DATE: NOVEMBER 25, 2024
TO: ALL PLAN HOLDERS
FROM: PATSY STINSON
PROJECT: MONTGOMERY REGIONAL AIRPORT
MONTGOMERY, ALABAMA
AIRFIELD ELECTRICAL REPLACEMENT - PHASE II
GMC PROJECT NO.: TMGM210029(R)
RE: ADDENDUM #1

ADDENDUM NUMBER 1

MONTGOMERY REGIONAL AIRPORT MONTGOMERY, ALABAMA AIRFIELD ELECTRICAL REPLACEMENT - PHASE II GMC PROJECT NO.: TMGM210029(R)

AIRFIELD LIGHTING & WIRING PLAN - TO AIRFIELD VAULT - PART 2
E15
Sheet 42 of 60

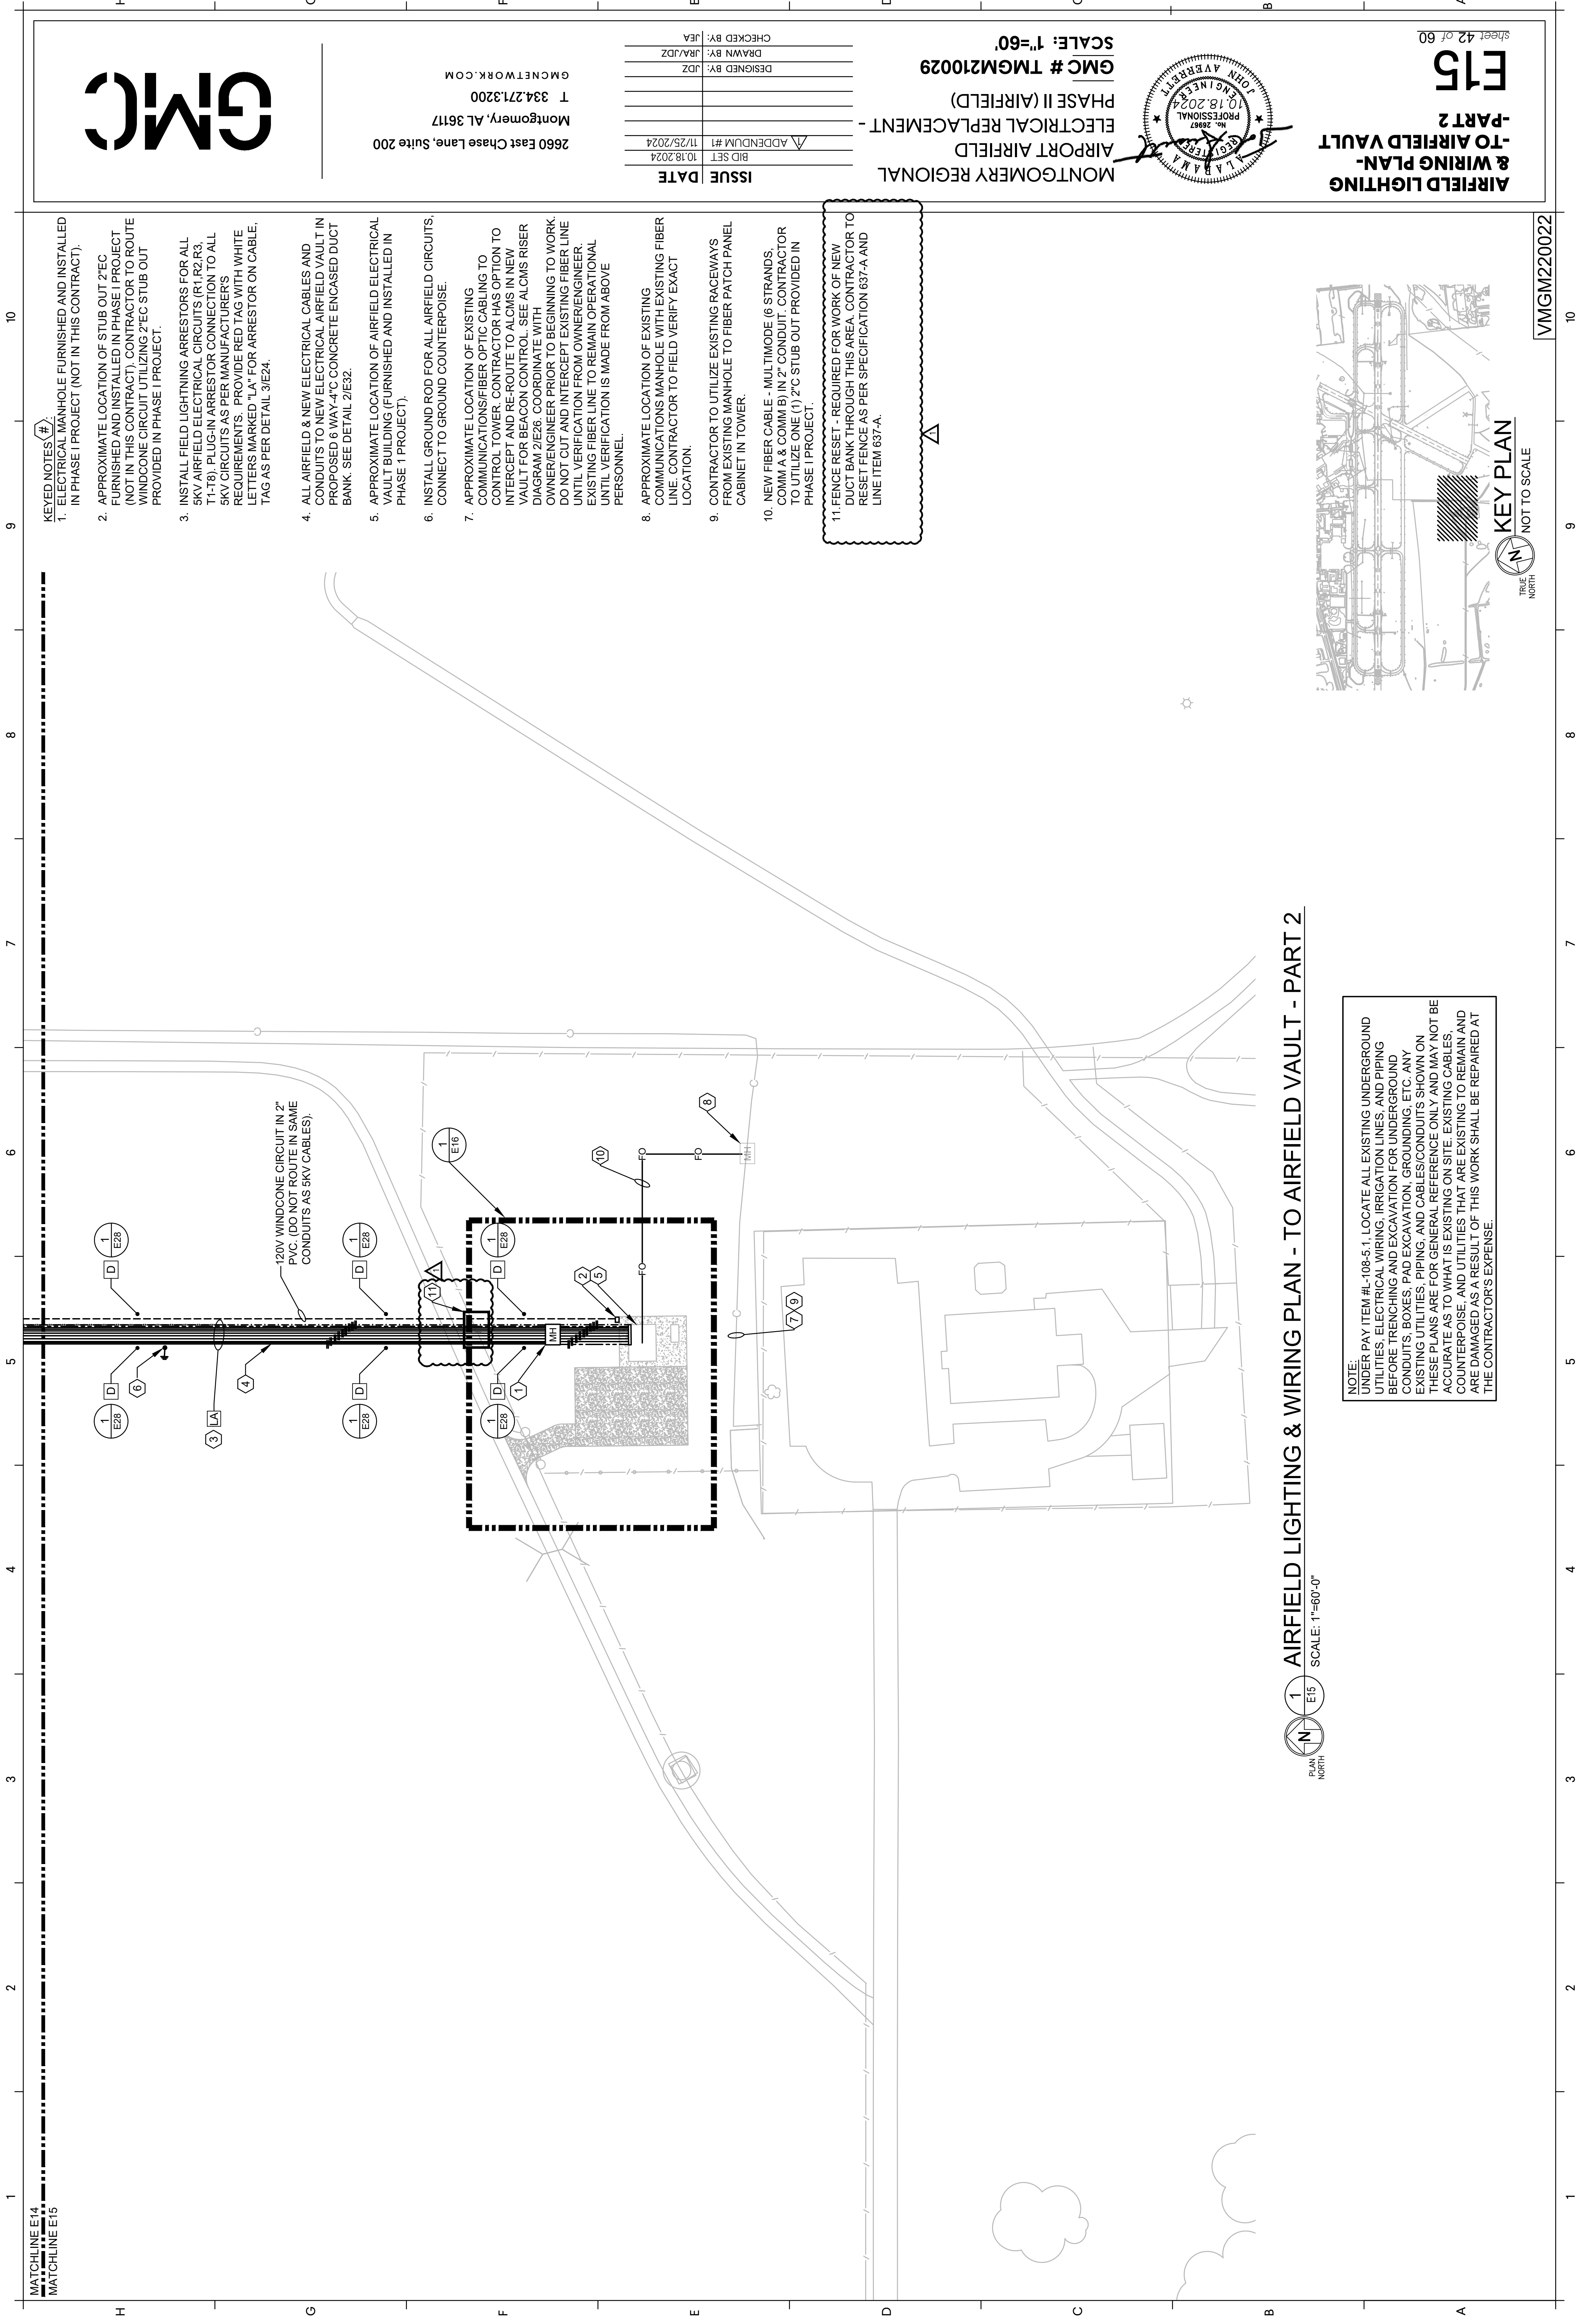
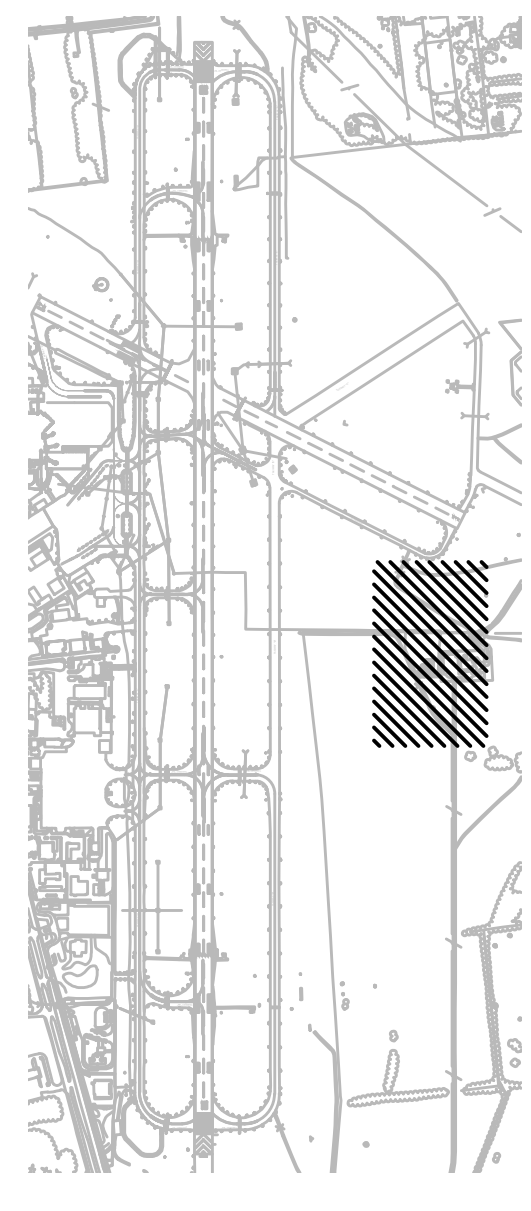
- See revised sheet E15 – Airfield Wiring and Lighting Plan to Airfield Vault
- See revised sheet GE3 – Revised Summary of Quantities

10. NEW FIBER CABLE - MULTIMODE (6 STRANDS, COMM A & COMM B) IN 2" CONDUIT. CONTRACTOR TO UTILIZE ONE (1) 2" C STUB OUT PROVIDED IN PHASE I PROJECT.
11. FENCE RESET - REQUIRED FOR WORK OF NEW DUCT BANK THROUGH THIS AREA. CONTRACTOR TO RESET FENCE AS PER SPECIFICATION 637-A AND LINE ITEM 637-A.
